Re: Vienna Market

This letter is to serve as a narrative to the changes being proposed specifically to the commercial retail space with townhomes and the corner park per the new board of architectural review meeting. This will also serve as the legend, with the numbers below tying back to the as built pictures. These items were deferred by the board:

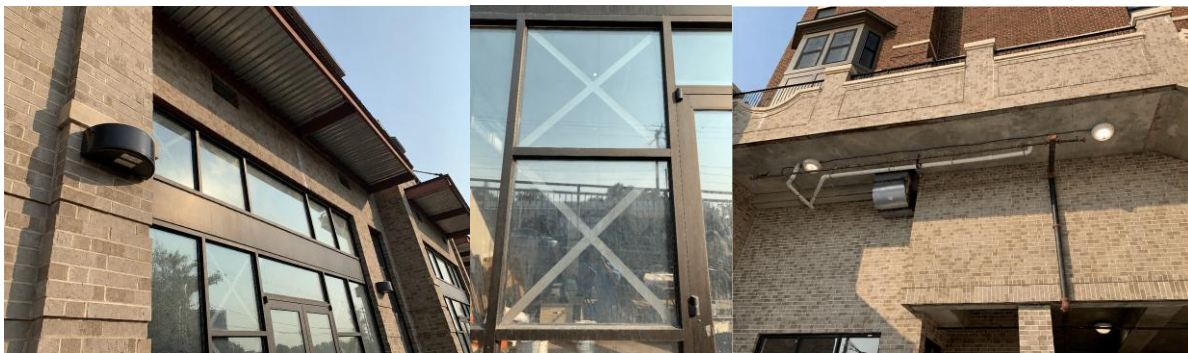
9. Comment: The raised brick planters at the edge of the corner plaza have not been constructed.

Response: Construct one-brick-high raised planters around each soil bed.
